PRODUCT UPDATE

Number: #127J
By: Applications Engineering Dept.
Date: November 14, 2013

Revised LEMO Elbow Plugs (00, B, S, K & E)
FHG.0K.3##.xxxxxx changes to FPG.0K.3##.xxxxxx
(This change includes all keyways)

Legacy FHG.0K.3##.xxxxxx	New FPG.0K.3##.xxxxxx

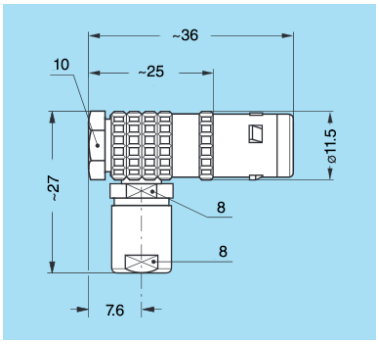
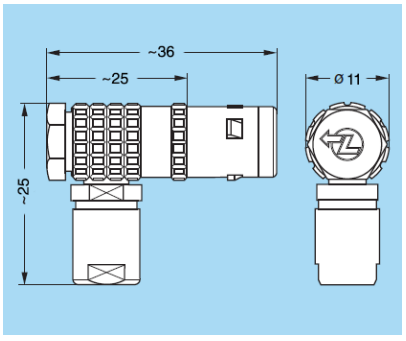
- New collet carrier design
- Anti-rotation collet design
- Same receptacle compatibility as FHG.0K.3##.xxxxxx
